Forest
Service

Superior
National
Forest

Date: January 13, 2012

Thank you for the opportunity to review the Regional Haze State Implementation Plan Supplement (Supplement). The Supplement focuses on the application of best available retrofit technology (BART) to the electrical generating units (EGUs) and taconite plants in Minnesota. BART is the last remaining part of Minnesota's Regional Haze Plan that needs to be completed.

Figure 1 – Comparison of Emissions Under CSAPR and BART for BART-subject Units in Minnesota

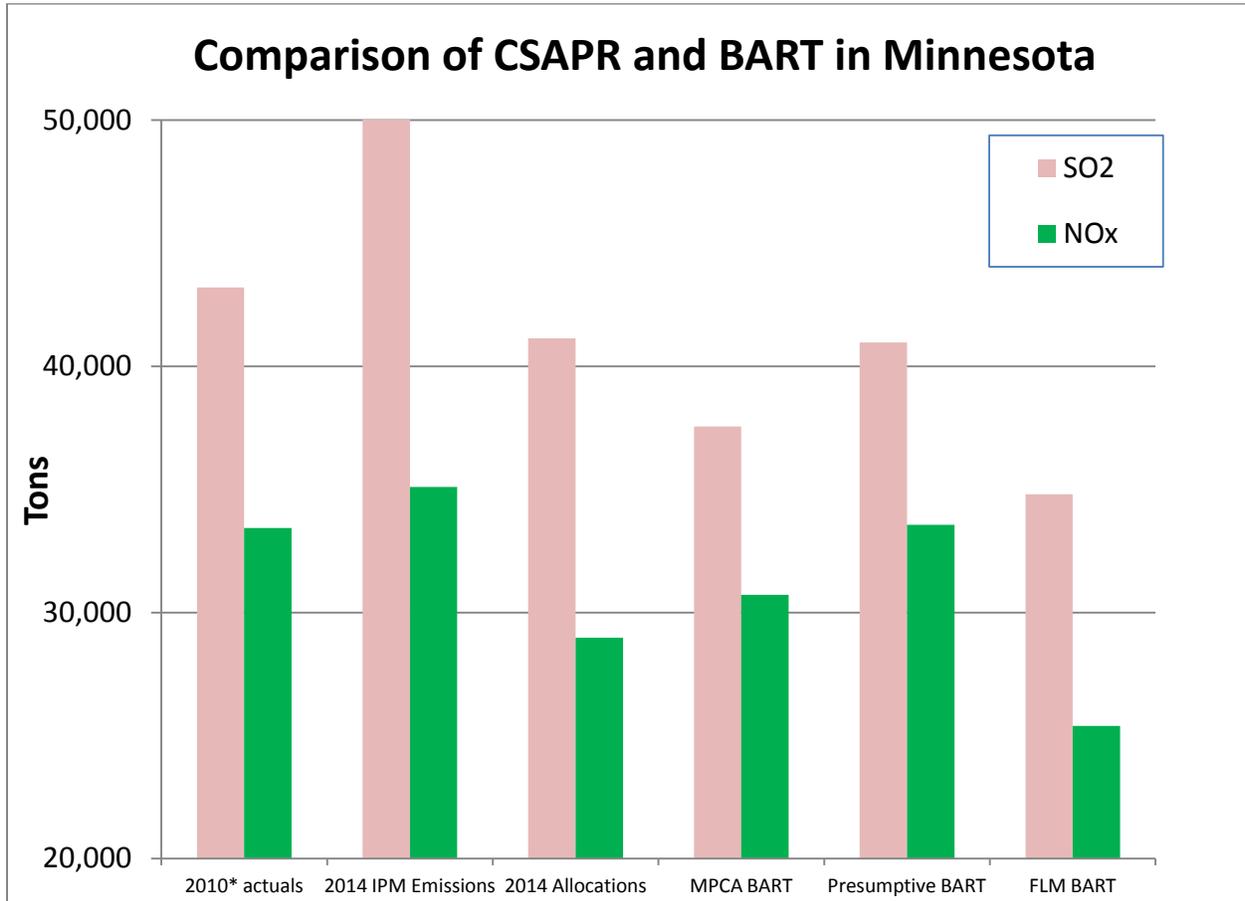
We do not agree that CSAPR is better than source-specific BART in Minnesota. No state-specific demonstration has been made that we are aware of. In the Supplement the emissions budget under the previous transport rule is compared to CSAPR. We do not see any value in this comparison. Both are different versions of the same trading program.

Instead we attempted to compare source-specific EGU BART to CSAPR for Minnesota in Figure 1. The graph shows that the IPM prediction of the affect of CSAPR in 2014 (i.e. “2014 IPM Emissions”) is an increase in emissions over current (2010) actual emissions. In addition CSAPR is well above both what was proposed as source-specific BART by MPCA and what we and the other Federal Land Managers (FLMs) proposed as source-specific BART. Without any other information specific to Minnesota we find source-specific BART to be far superior to CSAPR.

We strongly encourage the MPCA to reject using CSAPR as a replacement and believe the source-specific BART limit approach should be maintained. The MPCA should also re-evaluate the limits determined for Xcel Energy’s Sherburne County and Northshore Mining’s Power House and consider the comments made by EPA (in letters dated September 3, 2009 and June 6, 2011) and ourselves (in our 2009 letters). The recent stay of CSAPR puts its future in doubt. The regional haze plans are more than four years overdue already. Please do not delay the plan and visibility improvement any longer by keeping Minnesota’s Regional Haze Plan tied to any of the federal trading rules. Please use source-specific BART limits in this plan.

Figure 2 – Emissions of NO_x and SO₂ Under Various BART Options for United Taconite

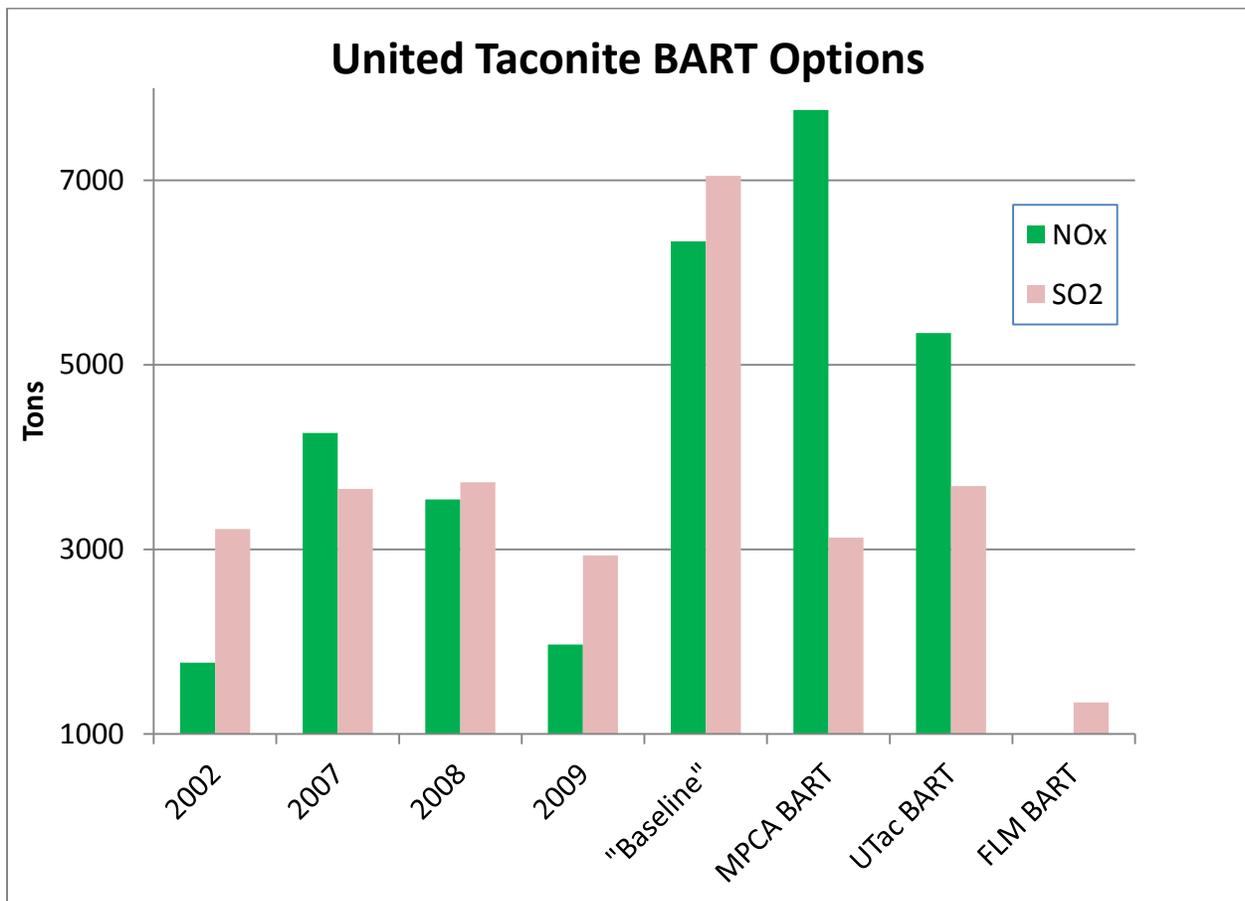
- The “reductions” in United’s proposal were calculated from an inflated baseline. The baseline values used in the Supplement rely on the baseline emissions value calculated in the permit for the plant expansion. Under those regulations the facility is free to choose the highest emitting two years in the past ten. As can be seen in Figure 2, the result is a value well above recent actual emissions.
- A major reason United’s proposed BART limits are more restrictive than the MPCA’s is because the MPCA’s NO_x limits were set artificially high for many of the same reasons detailed above. In the case of SO₂, as stated above, we believe the limit for line 2 should be 0.68 and not 1.7 lb/MMBtu.

The combination of these factors results in paper emission reductions. The following graph illustrates the point. It also includes actual emissions for 2002, 2007, 2008, and 2009.

The Supplement includes a table that is used to “demonstrate that the MPCA’s baseline BART proposal is essentially unconstraining, except for the SO₂ emissions limit for Line 2. Compared to past actual emissions, the MPCA’s BART proposal results in about a 2500 tons per year decrease in overall emissions of NO_x and SO₂ (*from “baseline”*). The proposal by UTac (*United*) results in a 4350 tons per year decrease in overall emissions as compared to the past emission scenario (*“baseline”*), and 1855 tons per year as compared to MPCA’s BART determination.” Note, clarification was added to the above text with the italicized words.

Figure 2 shows that all the BART proposals are unconstraining except for our BART proposal (which is based on the original BART determination for Line 1 in combination with a limit of 0.68 lb/MMBtu for Line 2). Since a proper BART analysis was not submitted for NO_x, we have no information from which to propose a BART limit for NO_x. Therefore no value was included in Figure 2 under FLM BART.

In summary please submit a full BART analysis for coal-fired Line 1 and correct the NO_x BART analysis for Line 2. The BART proposal in the Supplement does not include a consideration of the Clean Air Act factors for BART. It is irrelevant that the emission limit chosen is less than both an inflated baseline value, and an inflated, initial BART determination. The emission limit should be selected as an outcome of an analysis of the Clean Air Act factors.
